April 20, 2022

RE: Site Investigation

The Moore Property, Proposed Town Dog Park Weston, Connecticut

JMM Job # 22-3060-WES-2

FIGURE 1: Proposed Weston Dog Park: Davis Hill Road & Lord's Highway East, Weston, CT Town GIS Map Showing the Site Topography and the Majority of the Property Boundary of the Town Owned Parcel

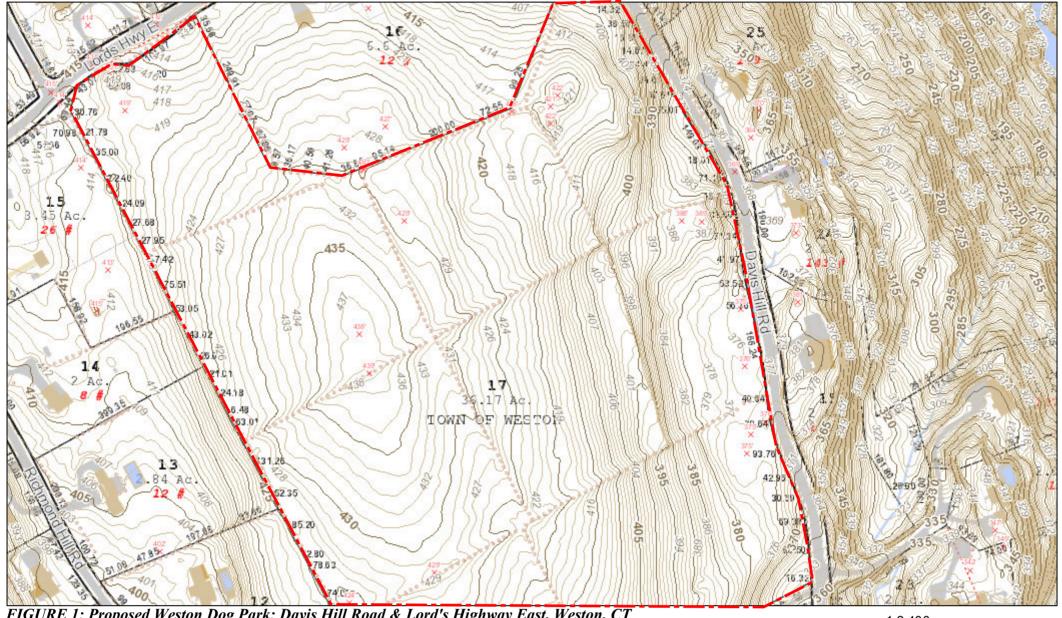
- During the April 18th site visit, we noted that the slopes within the eastern half of the proposed fenced area the slopes range from 12% to 15% with evidence of sheet flow and erosion noted near the stonewall, which would only be exacerbated by the proposed activities² (see Figures 1, 2 & 3, attached). Below the proposed limits of the fenced area, the slopes to the wetland boundary are even steeper, and it is very likely that flows will be concentrated not only leading to erosion and sedimentation of the wetland
